MILLSTONE NUCLEAR POWER STATION, UNIT NO. 2

AMENDMENT TO FACILITY OPERATING LICENSE

Amendment No. 113  
License No. DPR-65

SAFETY EVALUATION BY THE OFFICE OF NUCLEAR REACTOR REGULATION

FIGURE 3.2-3b Total Radial Peaking Factor vs. Allowable Fraction of RATED THERMAL POWER

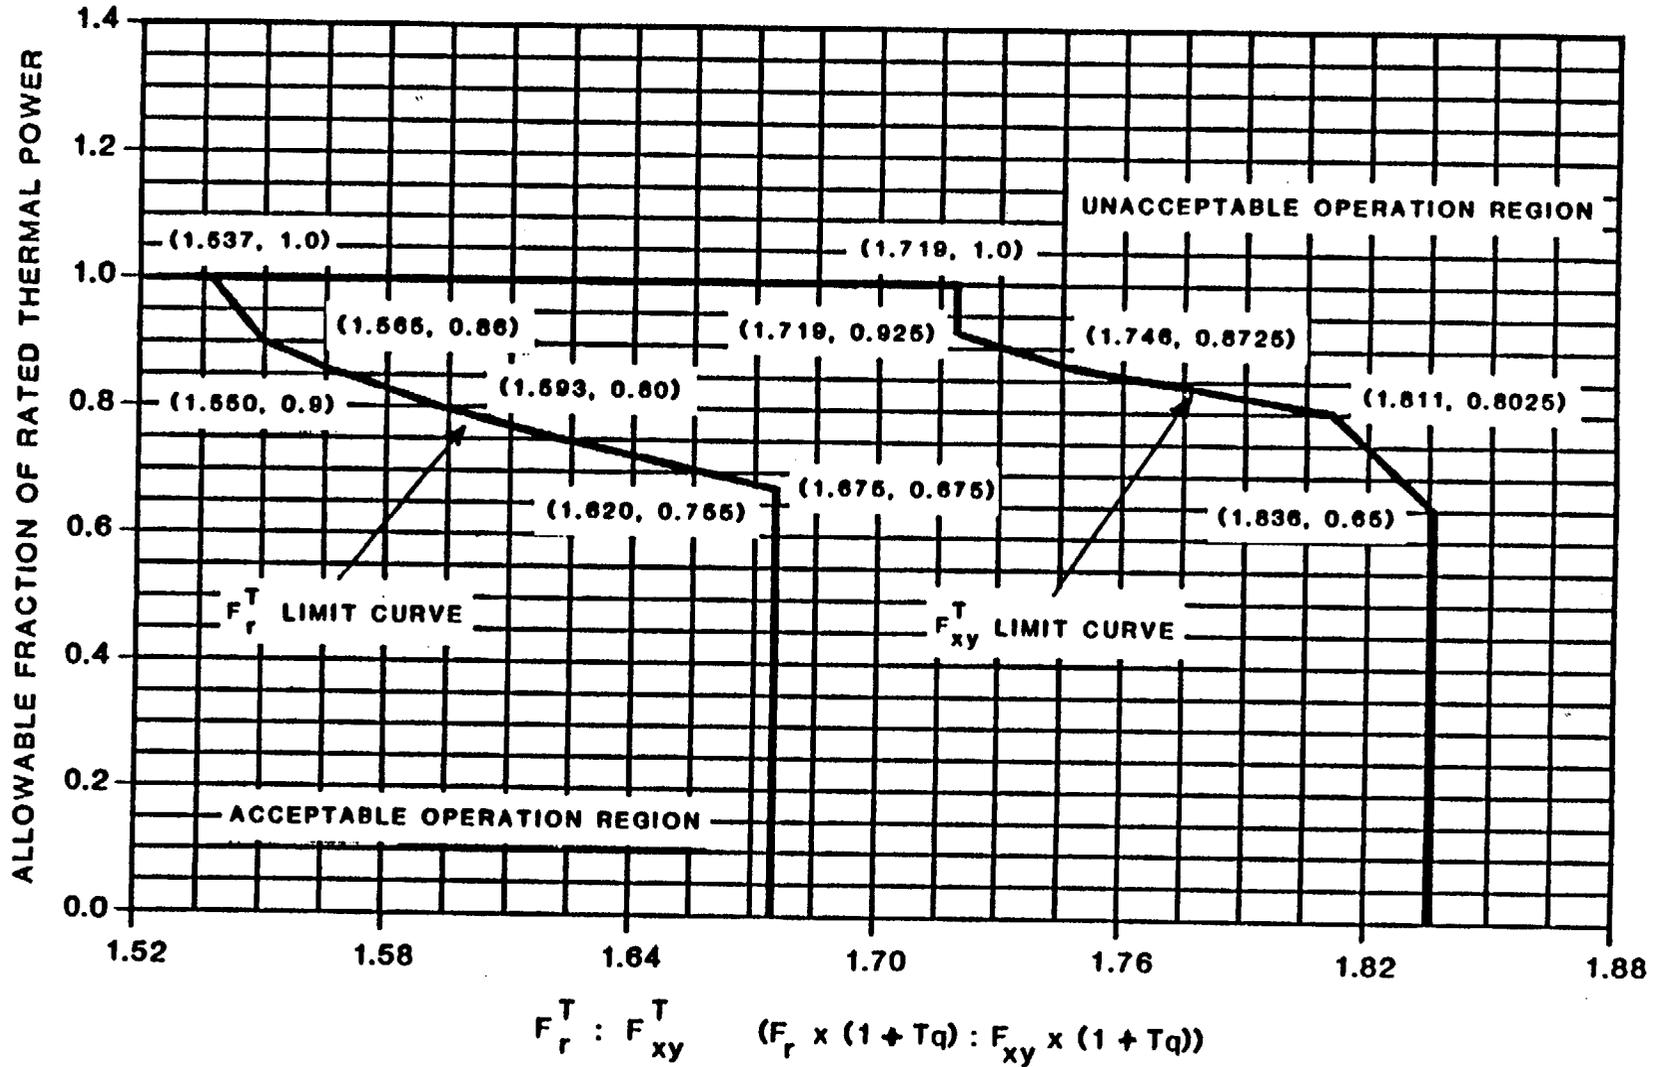
This proposed change affects TS Figure 3.2-3b and TS 3.2.3. The licensee's Cycle 4 reload safety analysis has shown that the DNB analysis penalty which results from a reduction in primary RCS flow rate can be offset by a reduction in allowable  $F_r$  in a 2:1 ratio of RCS flow rate to  $F_r$ . The proposed reduction in  $F_r$  more than offsets the RCS flow rate reduction. In addition, the Cycle 8 reload safety analysis confirms the acceptability of the transients and accidents with respect to the licensing basis criteria. Accordingly, these proposed changes to the TS are acceptable.

3.2.3 The calculated value of  $F_r^T$ , defined as  $F_r^T = F_r(1+T_q)$  shall be limited to  $\leq 1.537$ .

- a. Reduce THERMAL POWER to bring the combination of THERMAL POWER and  $F_r^T$  to within the limits of Figure 3.2-3b and withdraw the full length CEAs to or beyond the Long Term Steady State Insertion Limits of Specification 3.1.3.6; or
- b. Be in at least HOT STANDBY.

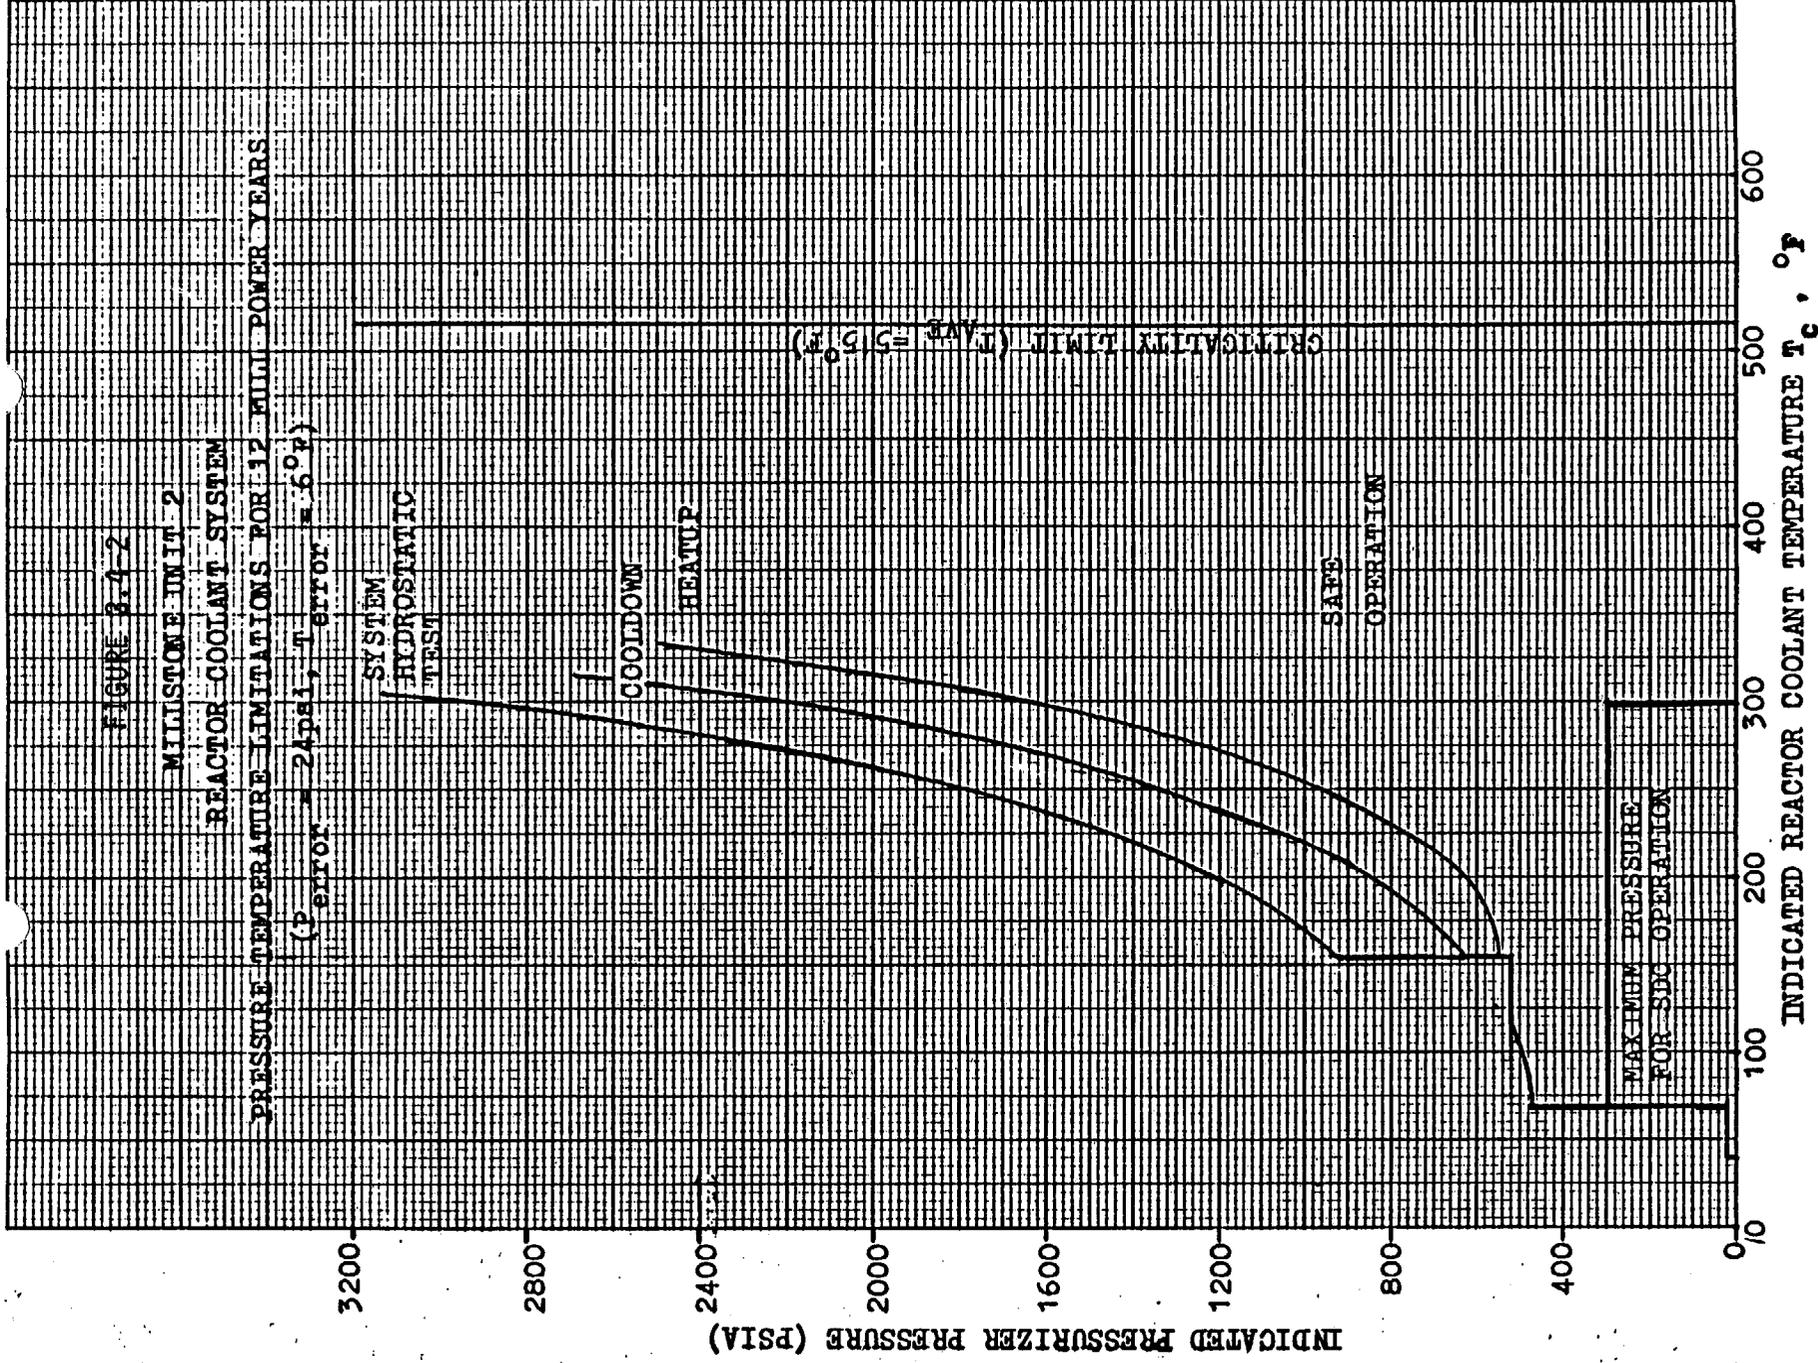
The October 20, 1986 application requested changes to the TS associated with pressure/temperature limitations. The proposed TS change involves new reactor vessel pressure-temperature limits for heatup, cooldown and the inservice hydrostatic test to be valid for 12 effective full power years (EFPY).

The heatup curve, proposed TS Figure 3.4-2, is a composite curve for reactor vessel pressure temperature limits. The heatup curve was calculated by starting at 70°F, then heating at a rate of 20°F per hour to 110°F, then 30°F per hour from 110°F to 140°F, and finally 50°F per hour to 550°F. This heatup sequence appears in proposed TS 3.4.9.1(a). The pressure-temperature limit curve computed by the staff and the licensee are essentially the same (differing by less than a nominal 2%) for heatup. The curve for pressure-temperature limit at 11.7 EFPY for heatup is, therefore, acceptable to the staff.

The cooldown curve, also shown in proposed Figure TS 3.4-2, is a composite curve for the reactor vessel pressure-temperature limits. The cooldown curve was calculated by starting at 550°F, then cooling at a rate of 80°F per hour to 300°F, 30°F per hour from 300°F to 200°F, and finally 20°F per hour from 200°F to 70°F. This cooldown sequence appears in proposed TS 3.4.9.1 (b). The pressure-temperature limit curve computed by the licensee bounds the curve computed by the staff for cooldown. The curve for pressure-temperature limit at 11.7 EFPY for cooldown is, therefore, acceptable to the staff.

Pressure-temperature limits for heatup and cooldown during core operations are obtained by adding 40°F to the temperature values in proposed TS Figure 3.4-2. Thus, a minimum critically temperature of 515°F is acceptable to the staff. Values of 156°F for the lowest service temperature and 70°F for the minimum boltup temperature are determined by considerations in the reactor coolant system other than the reactor pressure vessel. These temperature values are therefore acceptable to the staff. Also maximum service pressure of 520 psia is acceptable to the staff.

As indicated in Section 8.0, herein, the proposed heatup and cooldown curves in proposed TS Figure 3.4-2, and the proposed heatup and cooldown rates in proposed TS 3.4.9.1(a) and 3.4.9.1(b), are acceptable.

The staff has used the method of calculating pressure-temperature limits described in USNRC Standard Review Plan Section 5.3.2, NUREG-0800, Revision 1, July 1981, to evaluate the proposed pressure-temperature limits. The amount of neutron irradiation damage to the beltline material was estimated using the method documented in draft Regulatory Guide 1.99, Revision 2. The amount of copper and nickel in the controlling material, plate number C505-2, is 0.13% and 0.64% by weight, respectively. For the vessel inner surface, an end of license neutron fluence of  $5 \times 10^{19}$  n/cm<sup>2</sup> (E>1MeV) and a fluence of  $1.6 \times 10^{19}$  n/cm<sup>2</sup> (E>1MeV) at 11.7 EFPY is acceptable. The proposed pressure-temperature limits for inservice hydrostatic testing, heatup and cooldown meet the safety margins of Appendix G, 10 CFR Part 50 and may be incorporated into the technical specifications for the plant. Figure 3.4-2 is valid for 11.7 EFPY.
